Re:   TFC Addition  
      Drainage & Utility Concept

**STAFF REPORT**  
(Preliminary Plat)

**CASE NUMBER:** S/D 96-24 T.F.C. ADDITION

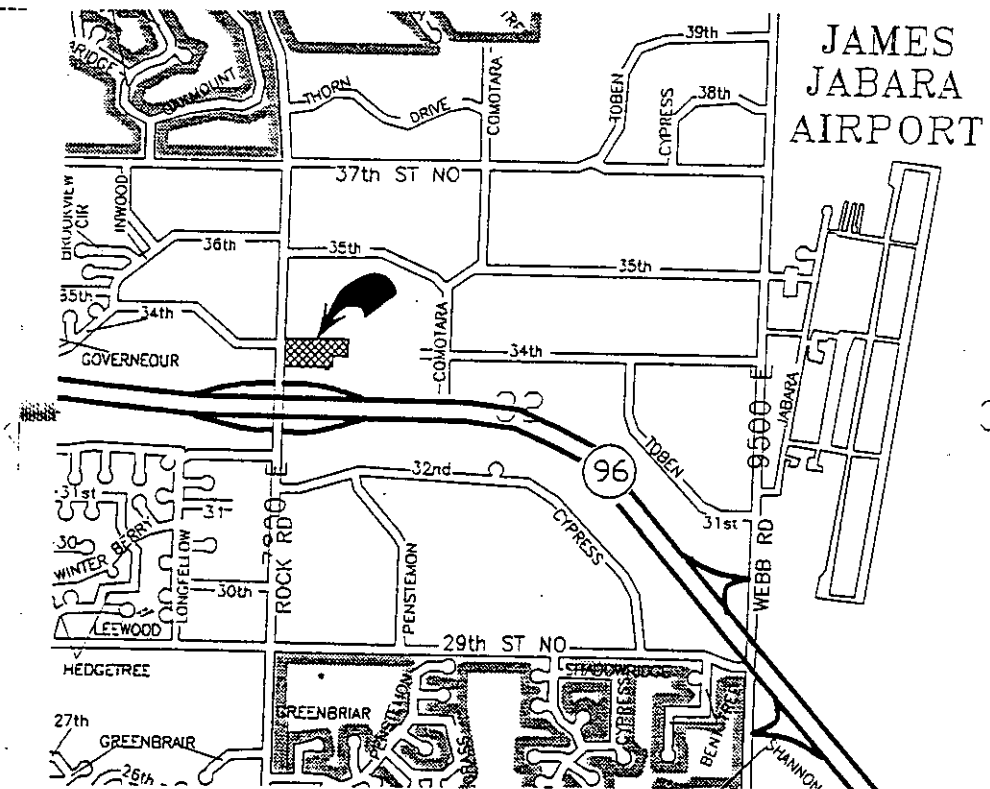
- A. City Engineering needs to comment upon any improvements needed to serve the additional lots now being created by this replat. That is, is City sewer and water presently available. In particular, are any drainage guarantees required by the City due to this site's major alteration to the site's drainage.

Both City Engineering and the Applicant need to indicate conditions or requirements involving the extensive "off-site" nature of the floodway changes.

- B. Traffic Engineering needs to indicate if any traffic improvements need to be guaranteed. Also, Traffic Engineering needs to comment on this plat's and the previously platted access controls for the site. This plat shows an existing opening at the center of the site being relocated to the north line of the site (Lot 1).

Technically, Lot 2 will have indirect access to a public street (Rock Road). Based on 'E' (LI) zoning, all lots are expected to have direct access to a public street. While moderate change in lot lines would allow both Lots to use the existing opening, if the proposed change in the location of the opening is necessary, an easement or agreement for cross-lot access will be required and needs to be created as a platting requirement. Again, Traffic Engineering needs to comment on the acceptability of such access in this case.

- C. If the access opening is changed (to as shown by this plat), the applicant shall guarantee the closure of the existing opening to Rock Road.
- D. If improvements are guaranteed by petition, a notarized certificate listing the petitions shall be submitted to the Planning Department for recording.

- I. As required for the original plat, a minimum building pad elevation shall be shown for this site, unless indicated otherwise by City Engineering.
- Both on-site and off-site benchmarks shall also be shown.
